# SHIFT SHAFT REPLACEMENT

**AFFECTED MODEL:  
 2020 1290 SUPER DUKE R**

Fig. 1

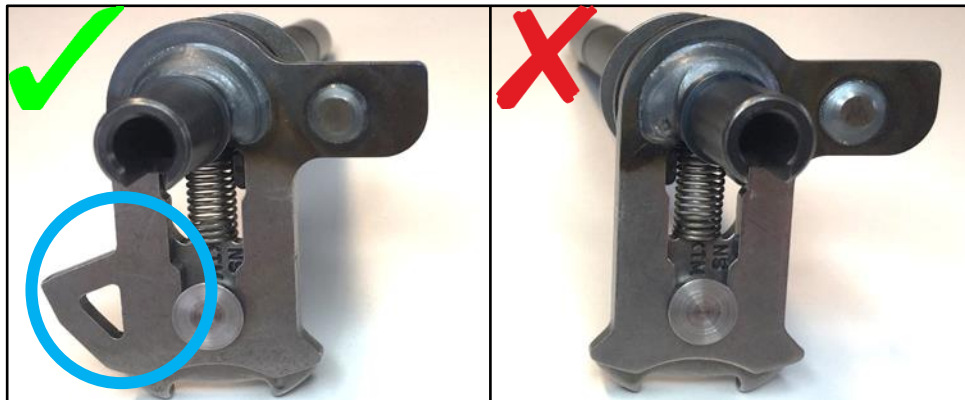
KTM North America, Inc. has determined that a deviation has been found with the shift shaft stop of certain 2020 1290 Super Duke R models. On affected VIN's the shift shaft stop may not be the proper length intended during gear changes. During operation this could cause the motorcycle to feel hard to shift. To remedy this the shift shaft must be replaced with a new revised version. The revised shift shaft P.N. 61734005044 (Fig.1) has a new additional stop which is pictured below to compare to with the original shift shaft.

P.N.- 61734005044
